# MIL "ON" DTC P1CB7A2

Some 2016 model year Prius vehicles may exhibit a MIL "ON" condition with Diagnostic Trouble Code (DTC) P1CB7A2 (Motor Generator System Voltage Low). The Hybrid Vehicle Control Computer (ECU) logic has been modified. Follow the Repair Procedure in this bulletin to address this condition.

**Figure 1. Location of Authorized Modifications Label for 2016 Prius**

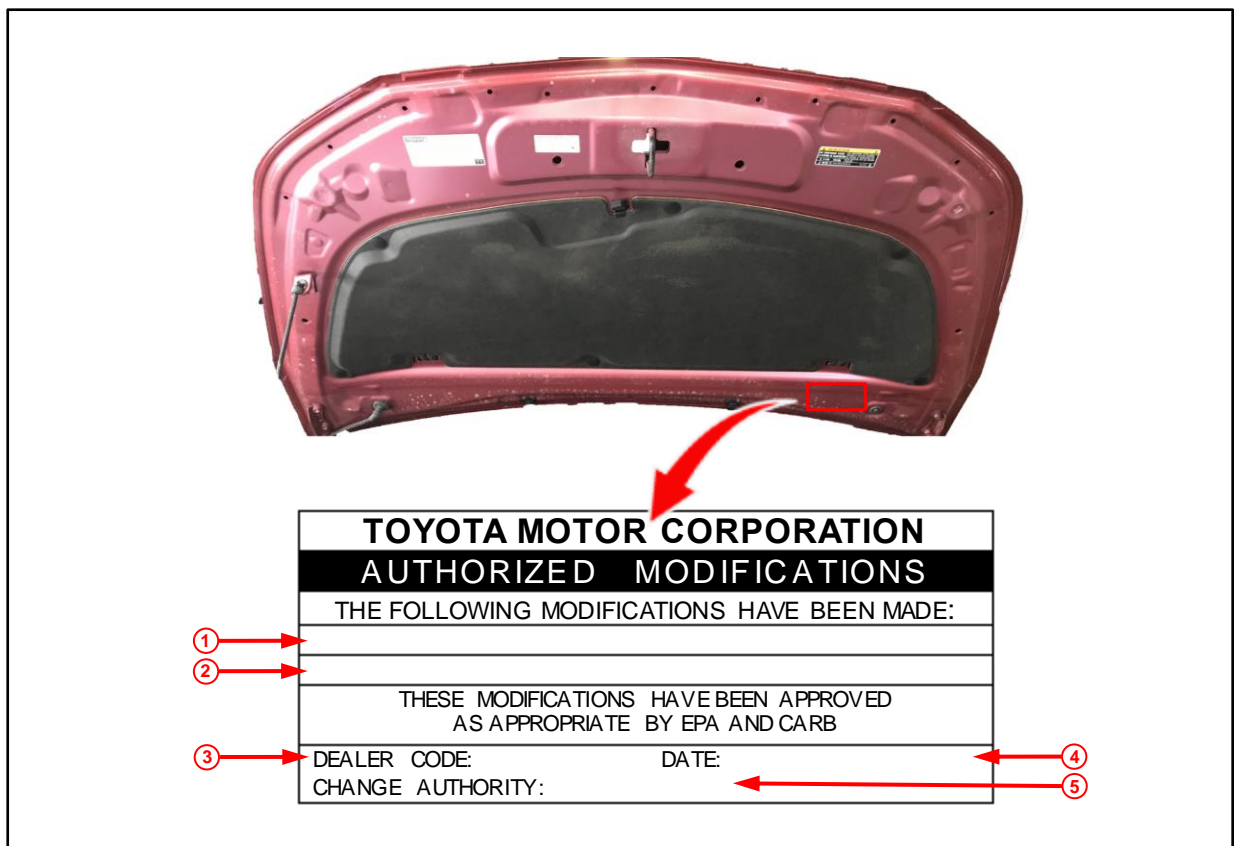
6. Check for the Authorized Modifications Label affixed to the vehicle in the location shown below. Confirm if the HV ECU calibration has been updated.

Is the calibration ID listed the latest HV ECU calibration?

8. Prepare and install the Authorized Modifications Label.
  - A. Using a permanent marker, enter the following information on the label:
    - HV ECU part number [Refer to the **Parts Information** section for the **NEW PART NUMBER**]
    - Calibration ID(s) [Refer to the **Calibration Information** section for the **NEW CALIBRATION ID**]
    - Dealer Code
    - Repair Date
    - Change Authority [**This bulletin number**]
  - B. Affix the Authorized Modifications Label to the vehicle at the location shown in Figure 1. The Authorized Modifications Label is available through the MDC, P/N 00451-00001-LBL.
9. Replace the inverter battery if required.
